NEW FEATURES

■ EXTERIOR

1. Front Design

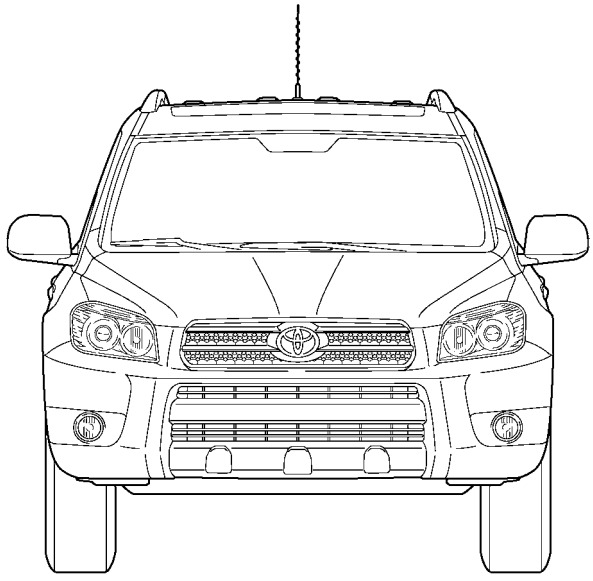
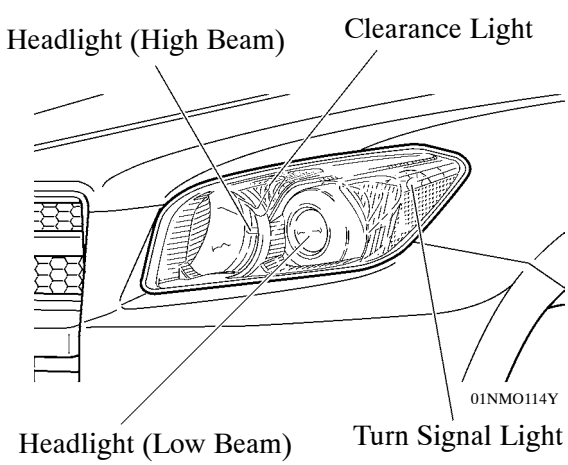
The front design on the models for Australia, G.C.C. countries, and general countries has been changed as follows:

- The design of the front bumper and radiator grille has been changed. A plated radiator grille is provided on the models for Australia with 2GR-FE engine.
- A newly designed headlight incorporating a front side turn light and a clearance light within the same lens is used.
  The models for Australia with 2GR-FE engine use a smoke-painted extension in the headlight to achieve a sporty design.
- The models with fog lights use plated rings for a luxurious look.

2. Rear Design

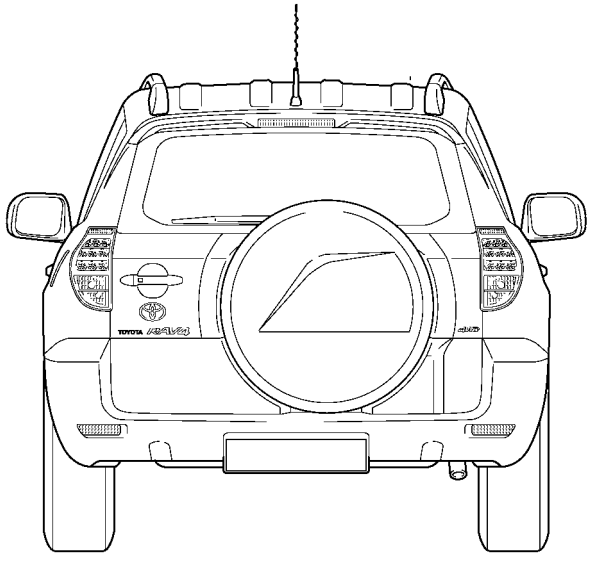
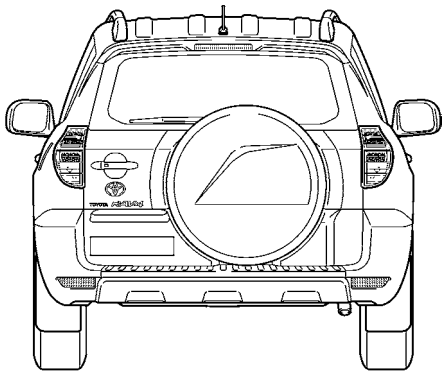
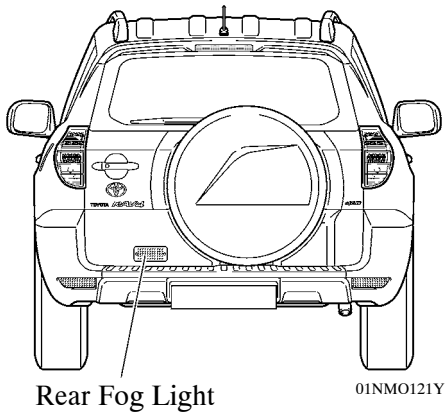
- The shape of the rear bumper has been changed. In addition, it is provided with a material portion to withstand abrasion during loading and unloading of cargo.
- The rear design varies by destination, such as a different position for installing the license plate.
- Newly designed rear combination lights are provided with 12 LEDs (Light Emitting Diodes) in the taillights and stop lights.

3. Side Design

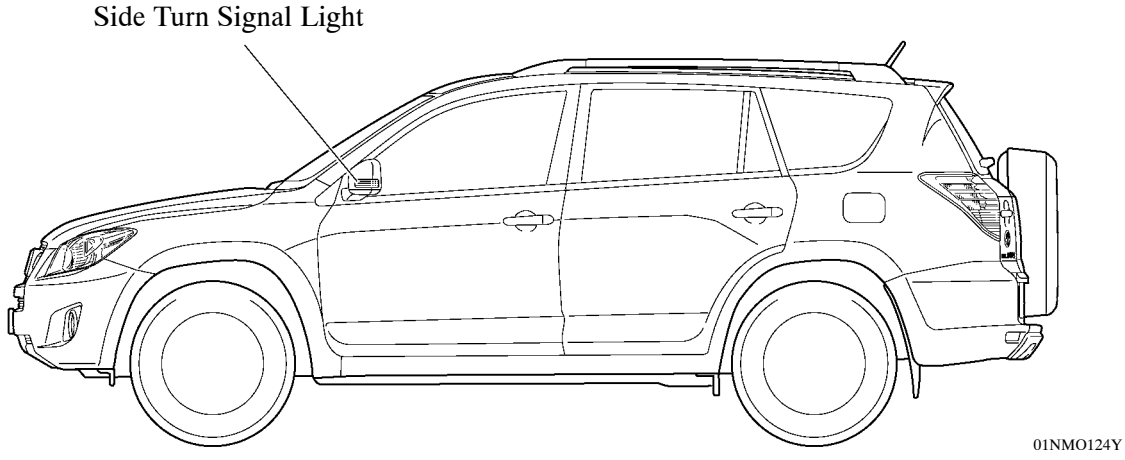
Outside rear view mirrors with attached side turn signal lights are provided as standard equipment on all models for Australia and G.C.C. countries and on the high grade of the models for general countries. They are also provided as optional equipment on the standard grade of the models for Taiwan with the automatic transaxle.
